Item ID: D206-642-341 Accept ***N900040100*** Setup Start ***NS1***
Revision ID: Stop ***NS2***
Item Name: Replacement Skidtube (Fits LH or RH)
Start Date: 9/13/2016 Start Qty: 1.00 ***1*** Cust Item ID:
Required Date: 9/23/2016 Req'd Qty: 1.00 ***1*** Customer:
Reference:

DESIGN	DS	DART AEROSPACE USA, INC	
DRAWN	AJS	PORT HADLOCK, WA	
CHECKED		DRAWING NO.	REV. F
MFG. APPR.		D2650	SHEET 2 OF 6
APPROVED		TITLE	SCALE
DE APPR.		206/407 SKIDTUBE ASSEMBLIES	NTS
DATE	08.08.08	COPYRIGHT © 1997 BY DART AEROSPACE USA, INC	
THIS DOCUMENT IS PRELIMINARY AND CONFIDENTIAL, AND IS SUPPLIED ON THE EXPRESS CONDITION THAT IT IS NOT TO BE USED FOR ANY PURPOSE OR COMMUNICATED TO ANY OTHER PERSON WITHOUT WRITTEN PERMISSION FROM DART AEROSPACE USA, INC.

DRAWING NO. D2650	TITLE 206/407 SKIDTUBE ASSEMBLIES	REV. F	DART AEROSPACE LTD ENGINEERING ORDER		D.E.O. NO. D2650-F-1	SHEET NO. SHEET 1 OF 1	SCALE NTS
DRAWN	CHECKED	A.P.	MFG. APPR.	APPROVED	DE APPR.		
DATE 12.10.12	DATE 12.10.22		DATE 12.10.22	DATE 12.10.22	DATE 12.10.22

CHANGE C'BORED WELDED CROSSBOLT SPACERS TO SWAGED SPACERS

DETAIL G

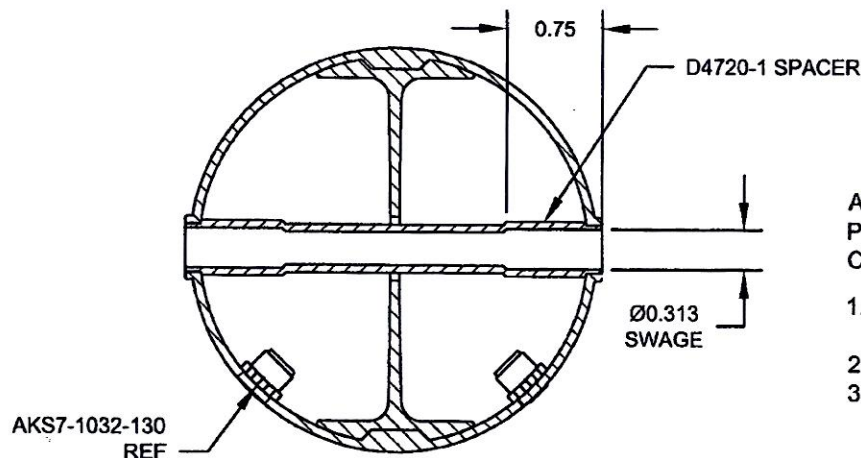
ADD DETAIL G BELOW, WHICH IS THE SAME SECTION VIEW AS DETAIL D OF DWG.

C'BORED HOLES ARE **NOW SWAGED** PER DETAIL G BELOW. FOR THE Ø0.375 HOLE THAT IS NOT C'BORED, WELD PER DETAIL D OF DWG (SEE AMENDED DETAIL B FOR REFERENCE).

FOR HOLES THAT ARE CURRENTLY C'BORED ONLY
